SOLENOID COVER/1977 AND LATER XL MODELS

Figure 1. Proper Test Setup

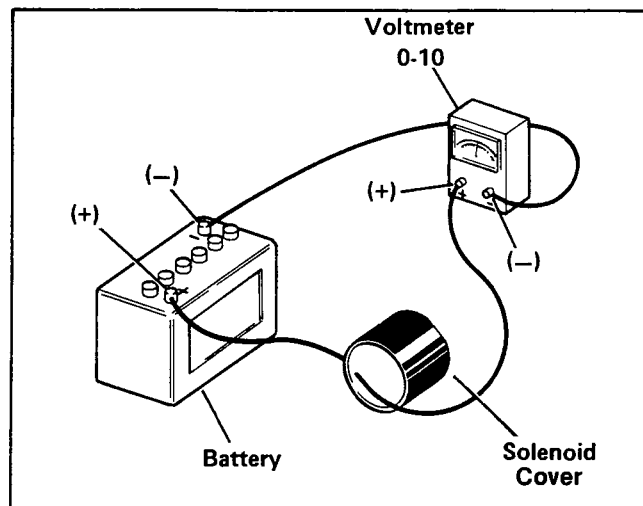
1. Set voltmeter to 10 volt scale.
2. First connect jumper wire to outside solenoid cover and battery positive post. Then connect voltmeter to inside solenoid boot and battery negative post (see Figure 1).

3. If needle reads anything or even flickers while solid contact is maintained, the cover is conductive.
4. If conductive, replace the solenoid cover, Part No. 31457-77. Hold replaced cover for possible inspection.
5. Before installing a new solenoid cover, check the replacement cover using the same procedure.
